# 1321 SENECA

RECOMMENDATION MEETING | DPD #3012930 | 02.20.13

# PROPOSED DEPARTURE

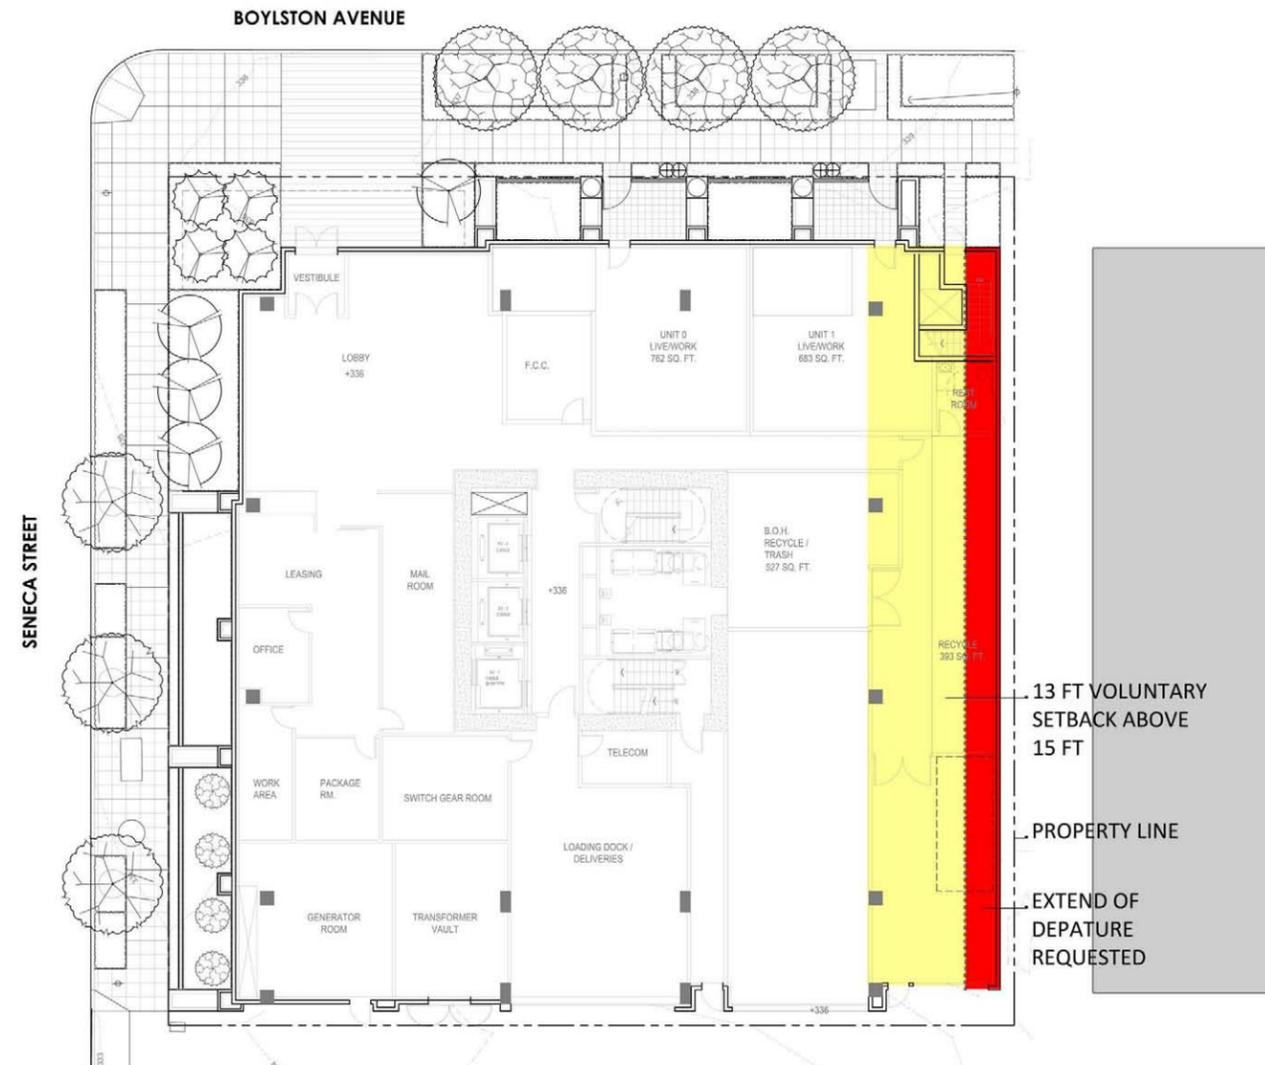
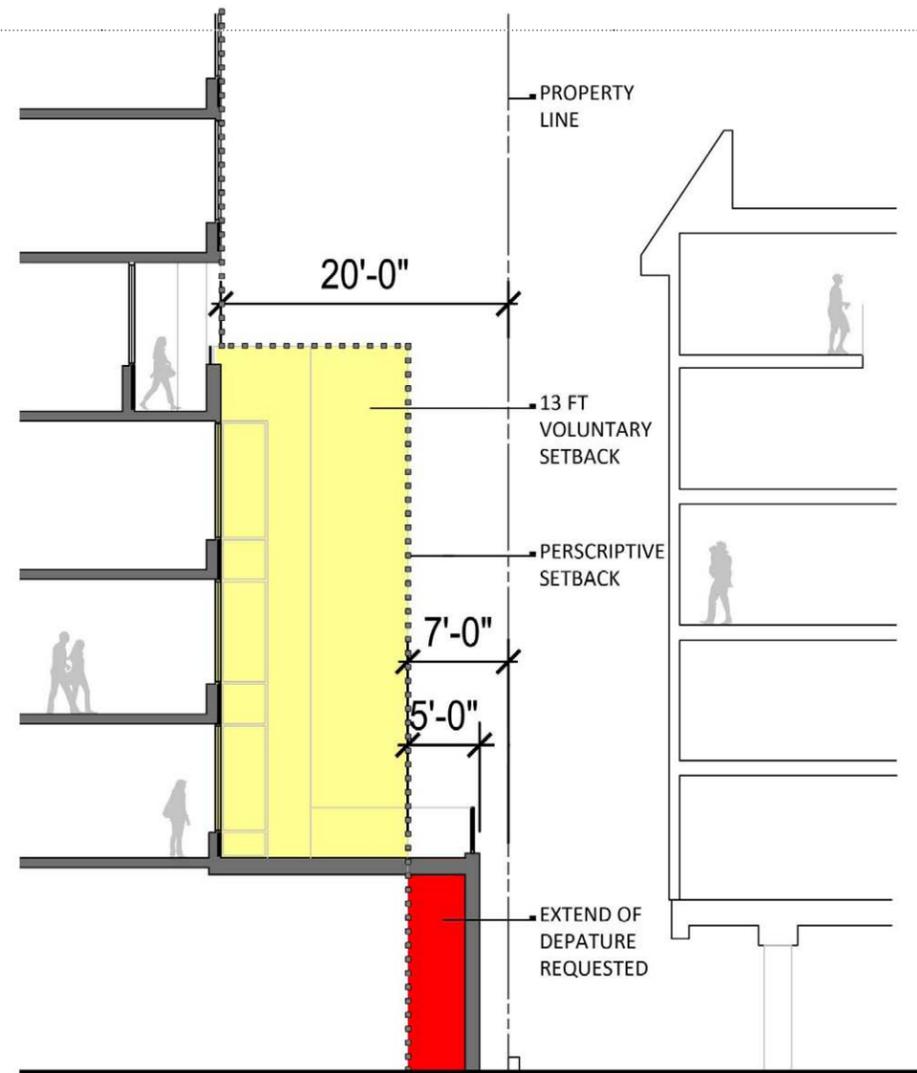
DEVELOPMENT STANDARD	REQUIREMENT	DEPARTURE REQUESTED	RATIONALE	DIAGRAM
SMC 23.45.518 HR SETBACKS	At lot lines abutting neither a street nor alley: Portions of a structure 45' or below: 7' average setback, 5' min.	At the lot line abutting the neighbor to the south: Portions of a structure 45' or below: 2' setback on ground floor and 15-20' set back on floors 2-4.	Allows for a more generous separation between podium and neighboring building to the south.	See Diagrams Below
